Leeds Bradford Airport Airspace Change

Respecting the Leeds Bradford Airport Airspace Change Proposal which appeared on the CAA website on 18th January 2019, we request that this application be called in for review by the Secretary of State on the grounds that one aspect of the proposals is likely to result in a net increase of more than 10,000 people becoming subject to aircraft noise in excess of 54 Db $L_{Aeq 16hr}$.

Figure 1: LBA's Diagrammatic Representation of Continuous Ascent Profiles

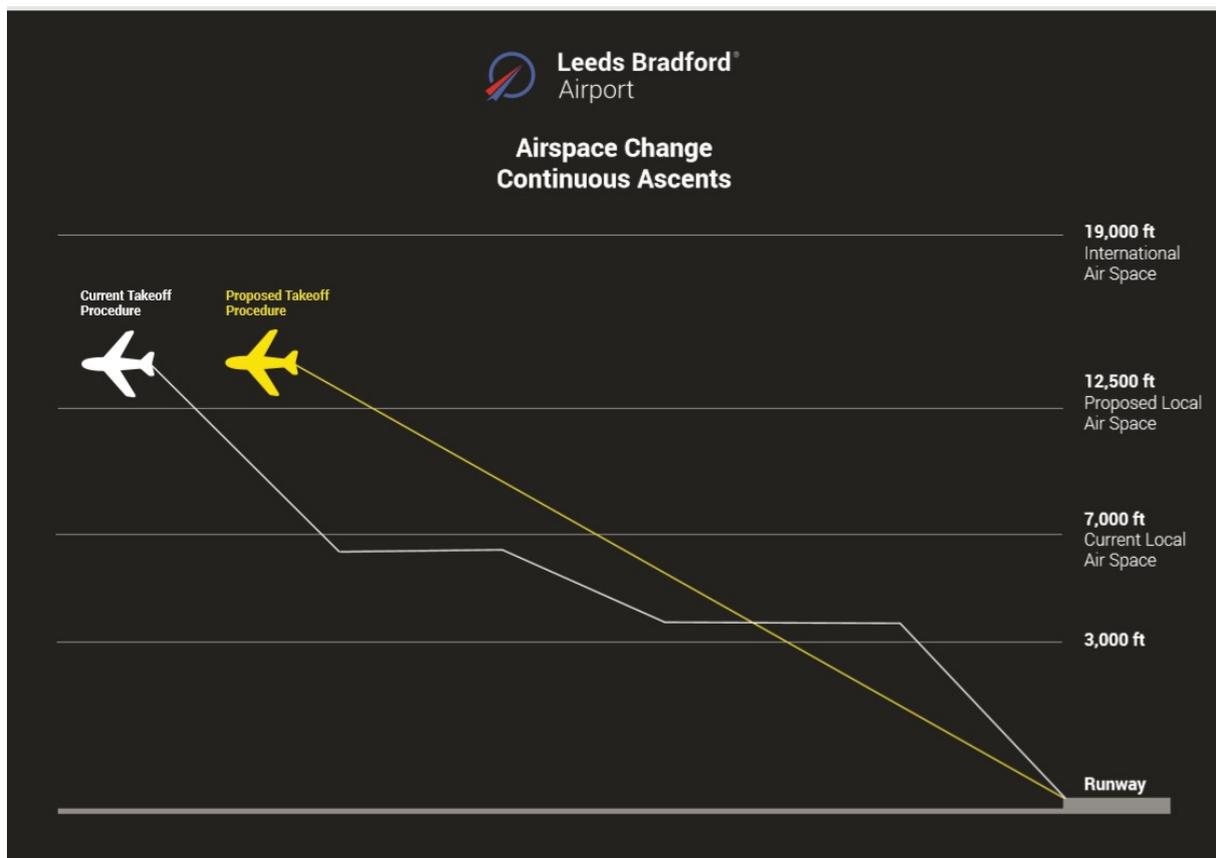
Paragraph 3.5.4 of the Consultation Addendum states that the L_{Aeq} modelling was unable to show the effect of changes in climb profiles and that the estimates of L_{Aeq} therefore represent a "theoretical worst case noise outcome; in reality we expect the noise levels to be lower than those modelled". This claim is made in the context of paragraph 3.4 which indicates that "the new arrangements will allow aircraft to make best use of modern performance characteristics, one of which is to allow aircraft almost unrestricted climb rates to maximum performance. This will therefore result in aircraft being at a similar or higher height than they are today". We understand the logic of the claim. **However**, a document sent by LBA to the MP for Leeds NW¹ indicates that, under the proposed arrangements "aircraft will take off at reduced thrust capacity ascents will be shallower" and an accompanying diagram (appended as Figure 1 below) indicated that, under the revised procedures, aircraft would cover about twice as much ground before reaching 3000 feet as they do under current procedures². Paragraph B262 of CAP725, indicates that the replacement of high-thrust-steep-ascents by low-thrust-shallow-ascents will increase sound exposure at ground level (because the reduction in sound emitted is more than offset by the decrease in attenuation). In which case, the $L_{Aeq 16hr}$ contours shown in the consultation document, rather than representing a theoretical worst case, would represent a significant underestimate the post-change noise levels.

We are well aware that our estimate of the blue zone in our Figure 2 is unlikely to be accurate, but we believe it to be the best estimate available in the public domain. We are aware that LBA have, since submitting their proposal to CAA, stated that Figure 1 is misleading (although it, together with its accompanying text, was produced and circulated by them as part of the consultation process). However, they have not disowned it in writing nor have they produced a replacement diagram, nor do any of their documents state that the new ascent paths will NOT be shallower than they are currently. We therefore think it prudent to submit this call-in request.
